Omaha Public Power District

Reference: Docket No. 50-285

INSPECTION EVALUATION REPORT

The following is an evaluation report of the inspection performed in response to the NRC's Generic Letter No. 81-14 (OPPD Task ES-81-01).

NOMOGRAPH FOR SEISMIC RESTRAINT SPACING

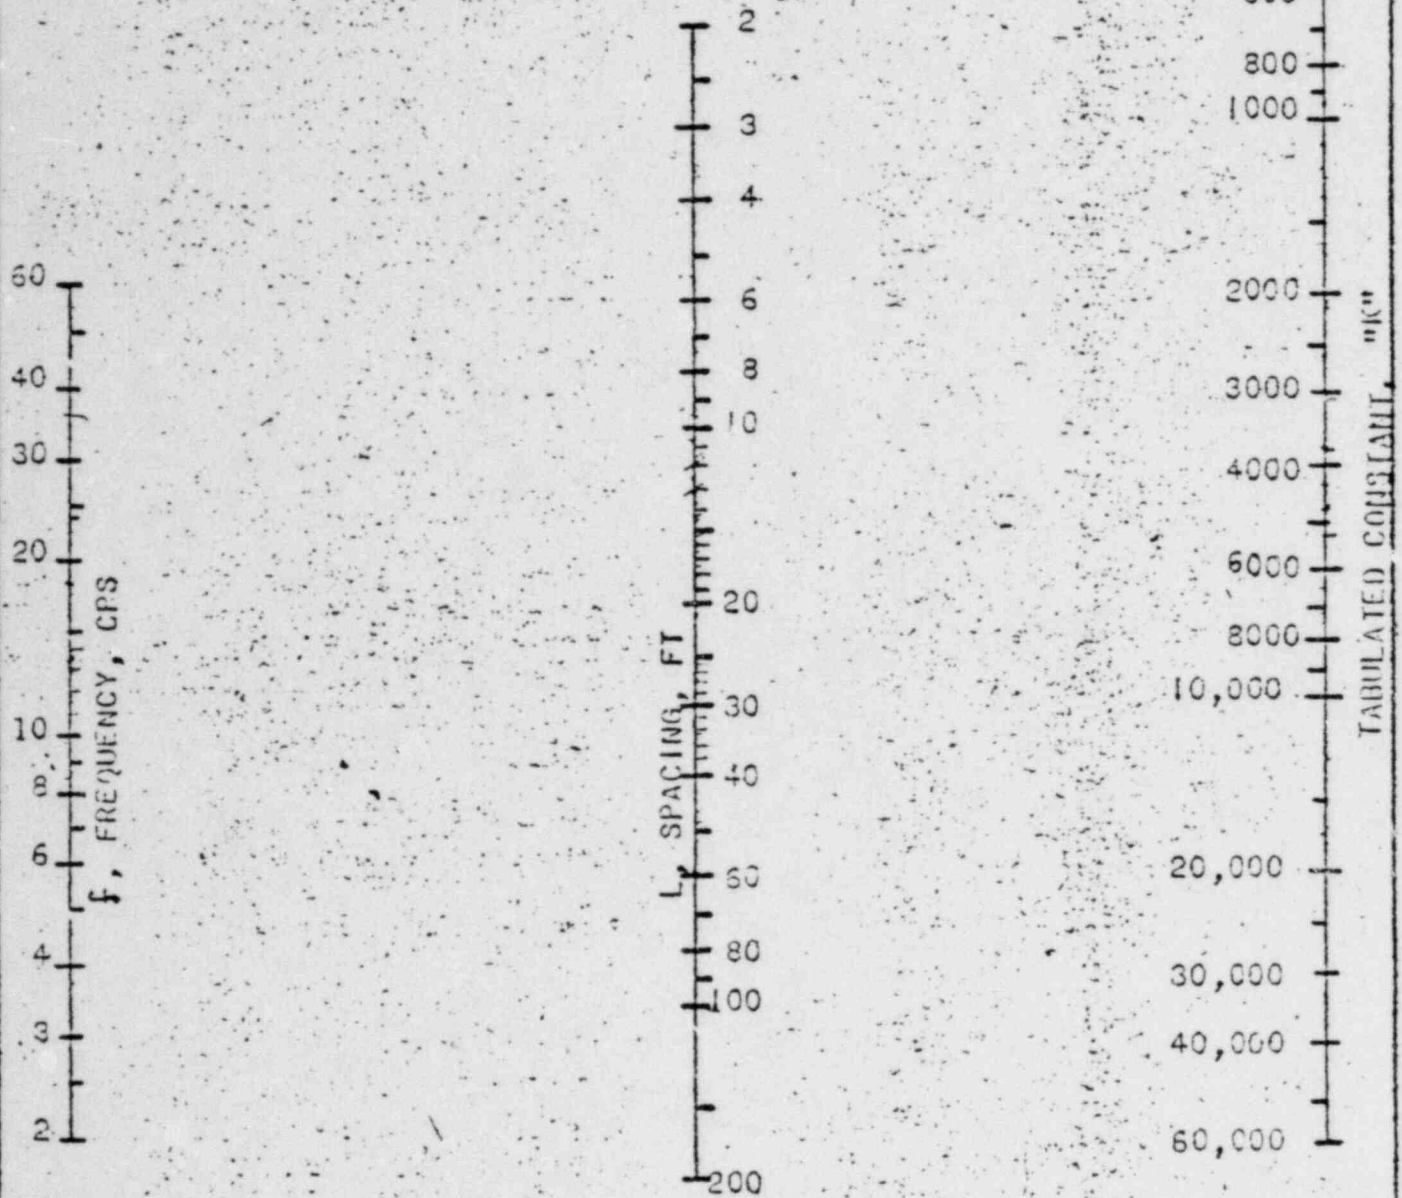
Using this nomograph (see Attachment 1, Sheet 8) the support spacing was found to be inadequate to achieve first mode frequencies of 18 CPS for vertical and 6 CPS for the horizontal. The following support modifications and additions are recommended to increase rigidity under seismic conditions. Also, the relative frequency is estimated for both as found and with proposed modifications (see Attachment 1).
